City of Puyallup Development Engineering APPROVED

PRMU20240401

EAST TOWN CROSSING
BUILDING 'D'
PIONEER & SHAW PUYALLUP WA

DRAWN BY:	BL / CM
CHECKED BY:	BL
DATE:	24.03.11
TITLE:	SITE PLAN *REF. ONLY
PROJECT # :	2016
SHEET:	AS1.0

1 OVERALL SITE PLAN - PHASE 1
SCALE: 1" = 40'

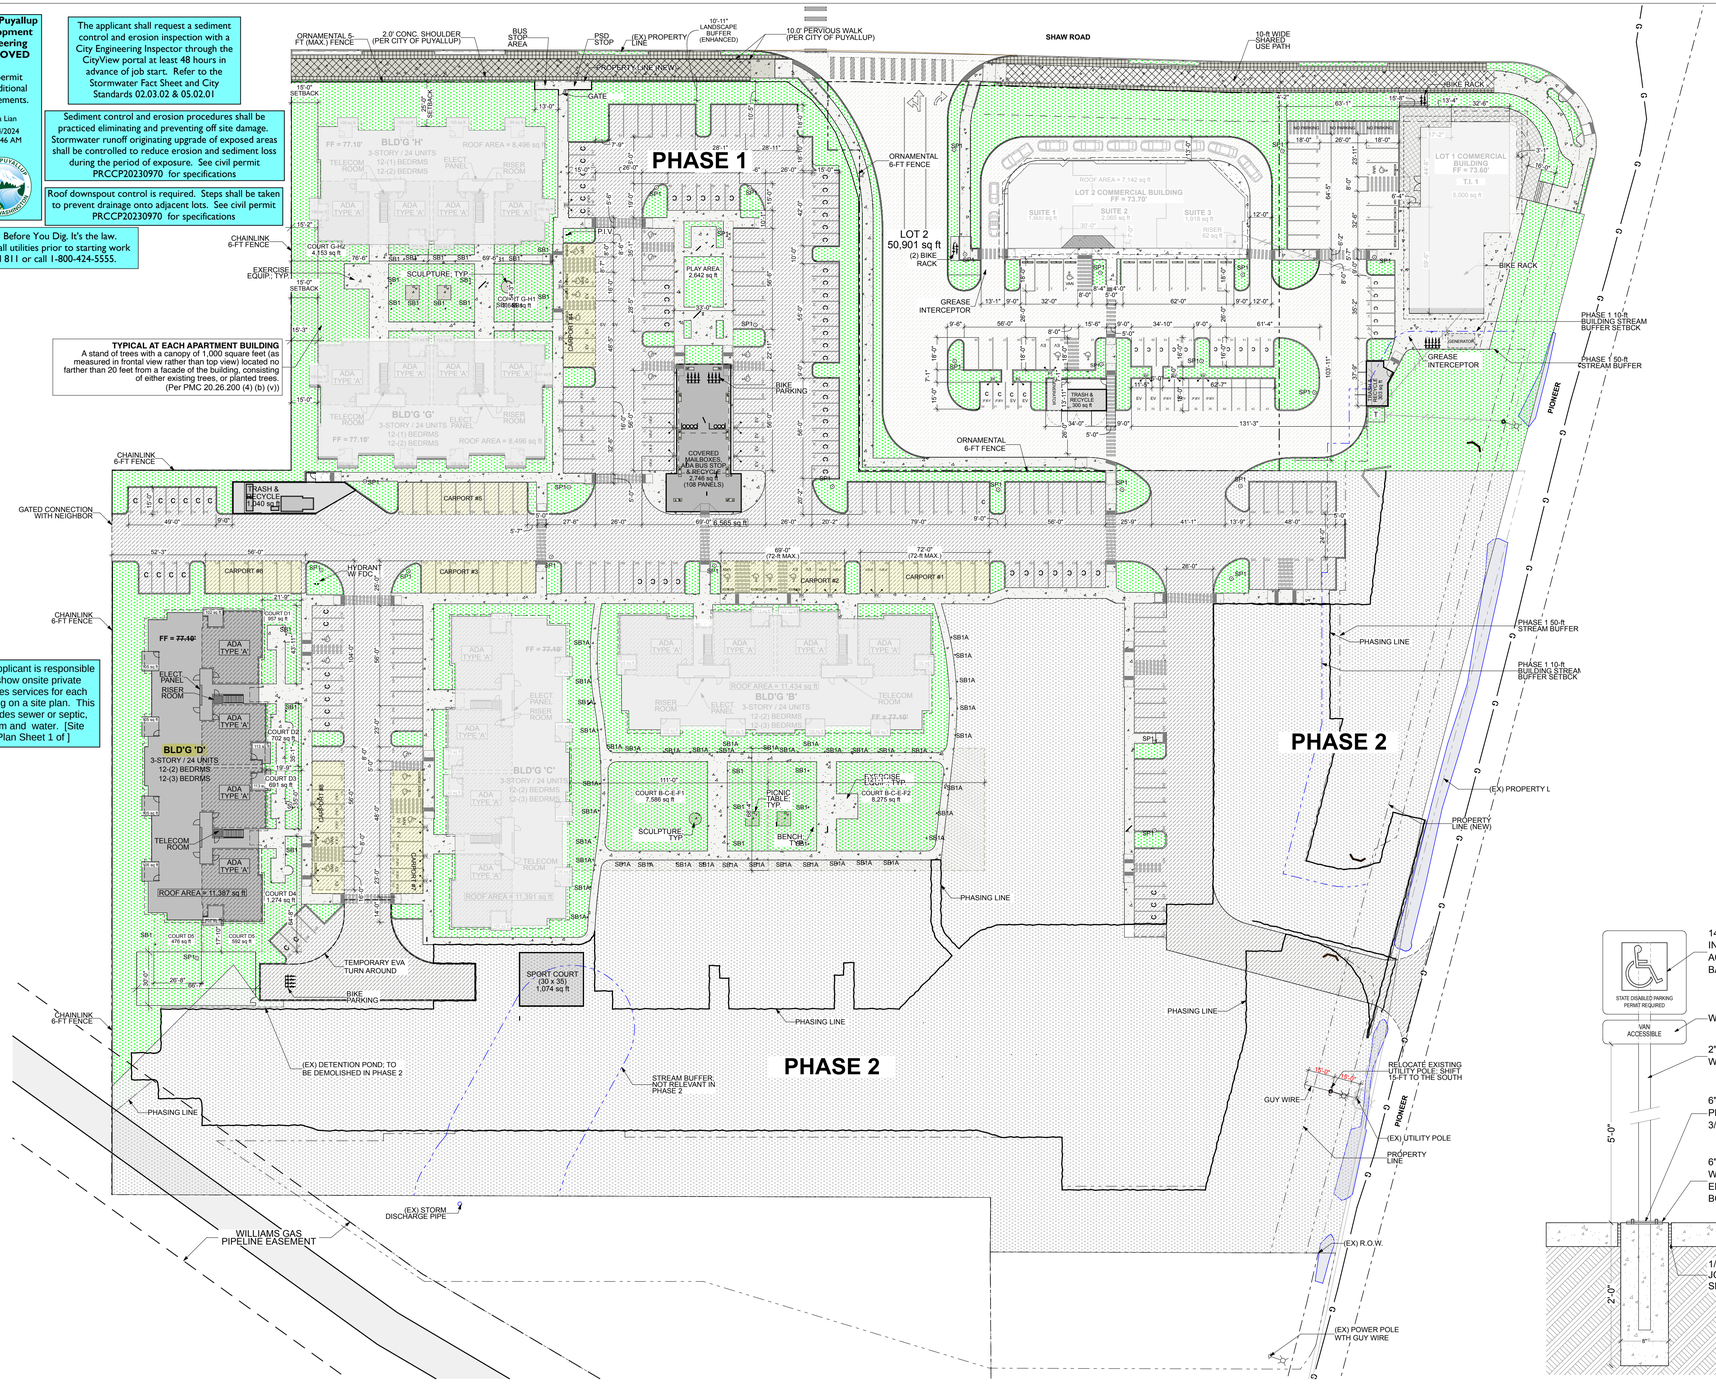
The applicant shall request a sediment control and erosion inspection with a City Engineering Inspector through the CityView portal at least 48 hours in advance of job start. Refer to the Stormwater Fact Sheet and City Standards 02.03.02 & 05.02.01

Sediment control and erosion procedures shall be practiced eliminating and preventing off site damage. Stormwater runoff originating upgrade of exposed areas shall be controlled to reduce erosion and sediment loss during the period of exposure. See civil permit PRCCP20230970 for specifications

Roof downspout control is required. Steps shall be taken to prevent drainage onto adjacent lots. See civil permit PRCCP20230970 for specifications

TYPICAL AT EACH APARTMENT BUILDING
A stand of trees with a canopy of 1,000 square feet (as measured in frontal view rather than top view) located no farther than 20 feet from a facade of the building, consisting of either existing trees, or planted trees. (Per PMC 20.26.200 (4) (b) (v))

The applicant is responsible to show onsite private utilities services for each building on a site plan. This includes sewer or septic, storm and water. [Site Plan Sheet 1 of]
